From: Malcolm Tempest Ltd
Sent: 27 March 2019 12:33
To: Ailsa Teasdale
Subject: NYM/2018/0310/FL

Project Name and Address
Honey Bee Nest
Glaisdale
North Yorks
YO21 2QL

Project	TOPO	Sheet	Dwg No.
Date	24.05.2018		8099/1/4
Scale	1:250

Proposed Site layout:
apx 1:250
June 2018.

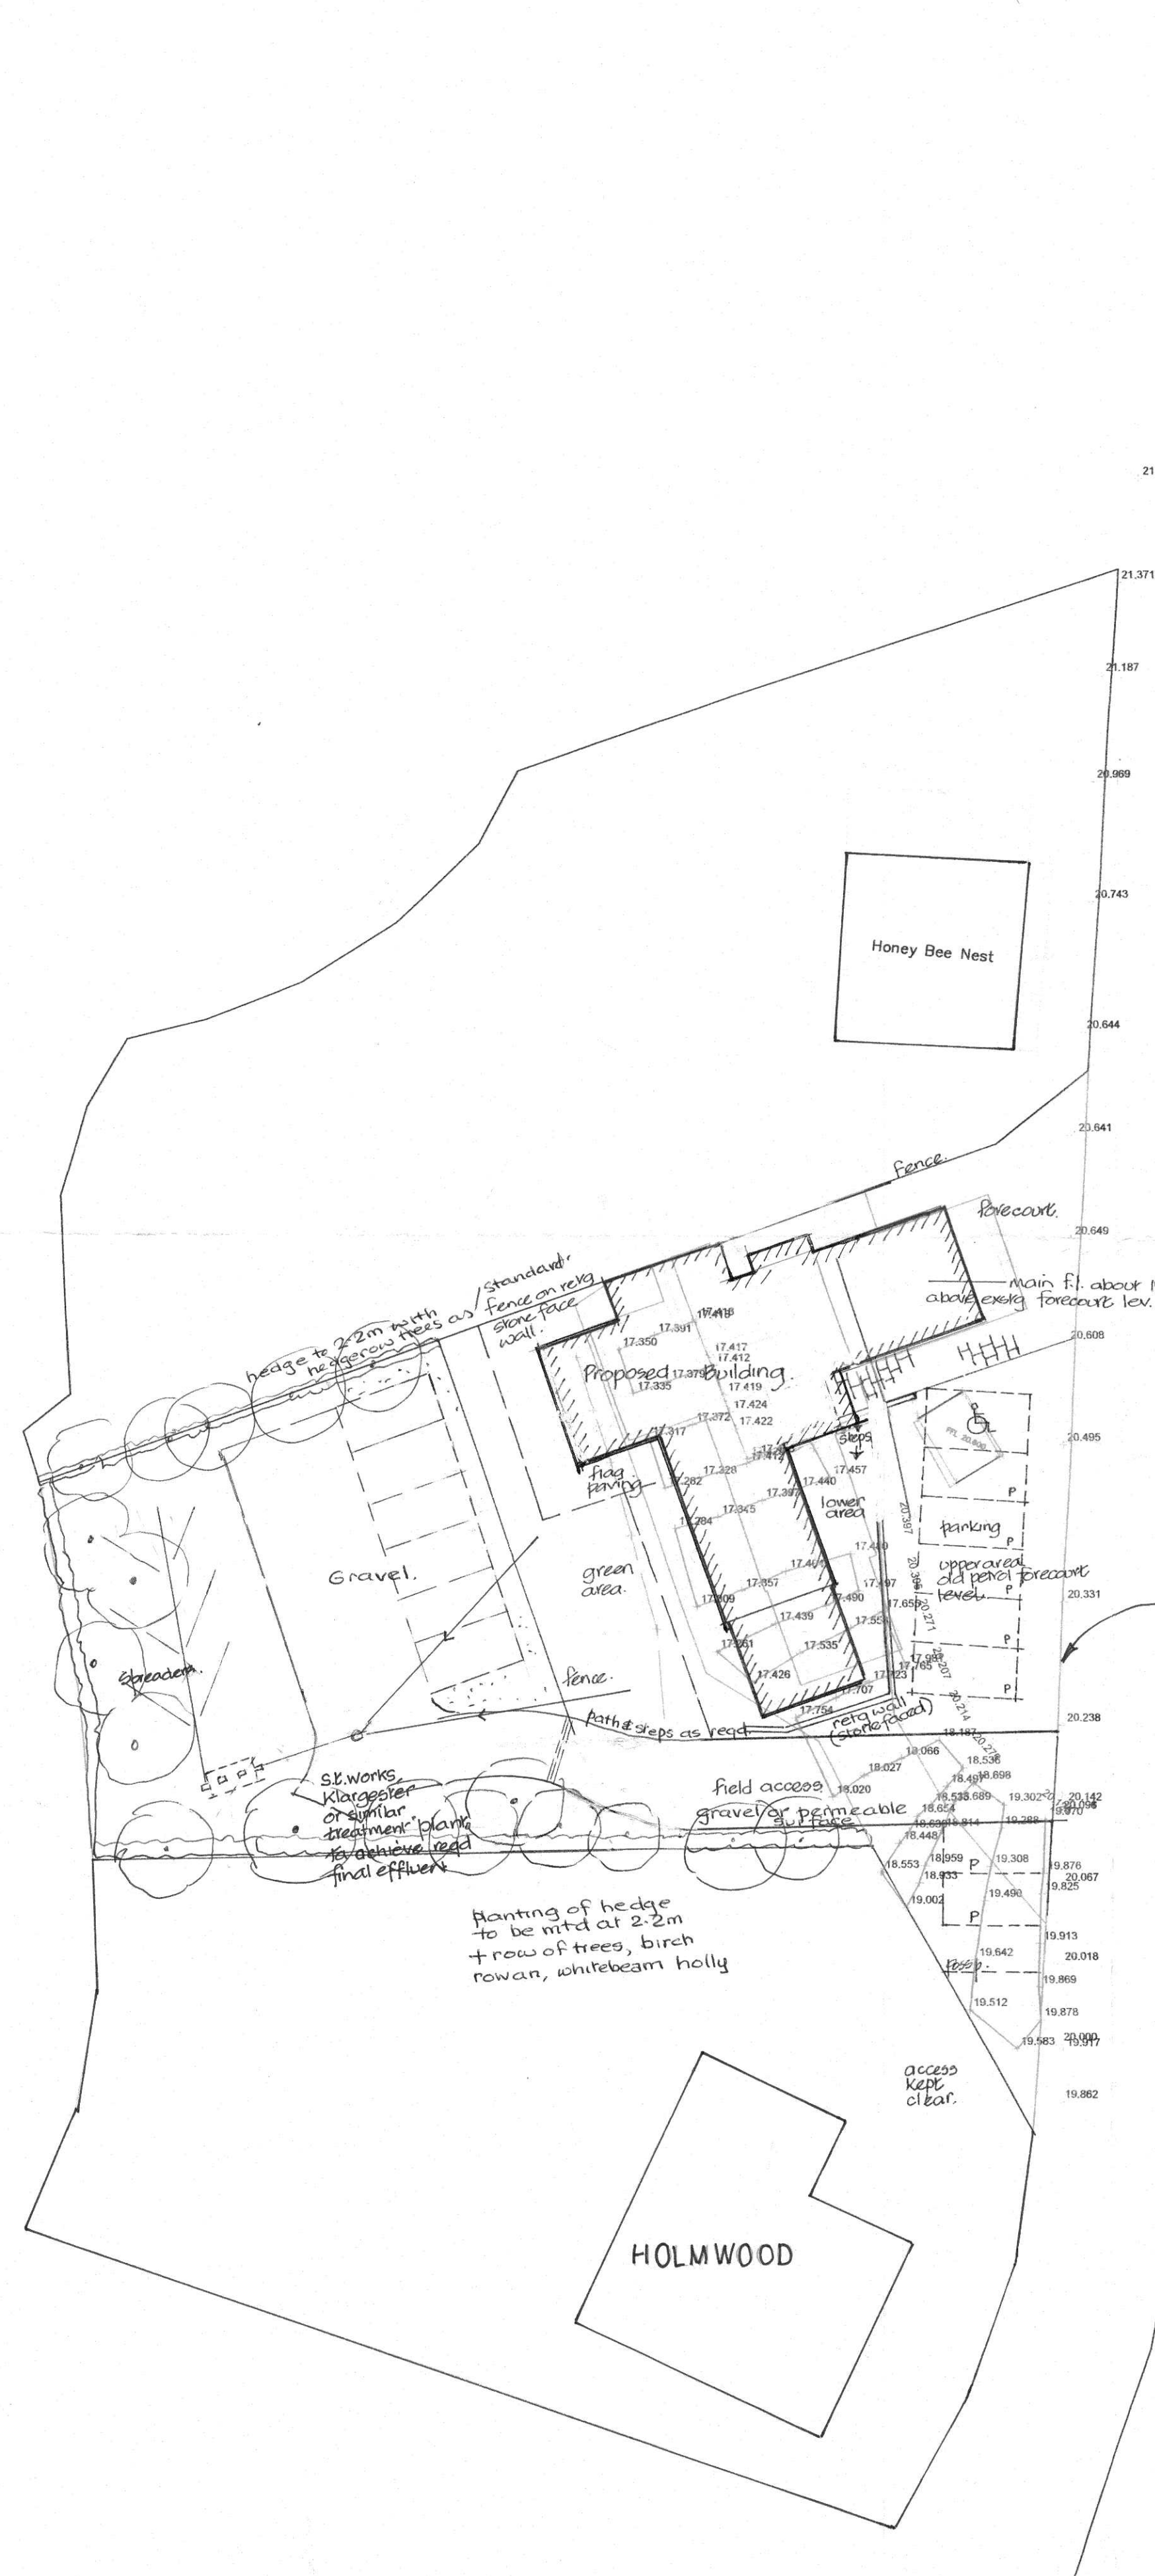
- Yes there is availability for additional parking and I have marked on the plan an additional 6 spaces at the lower level which can be gravel so be free draining. This could be accommodated within the site with landscaping as indicated.
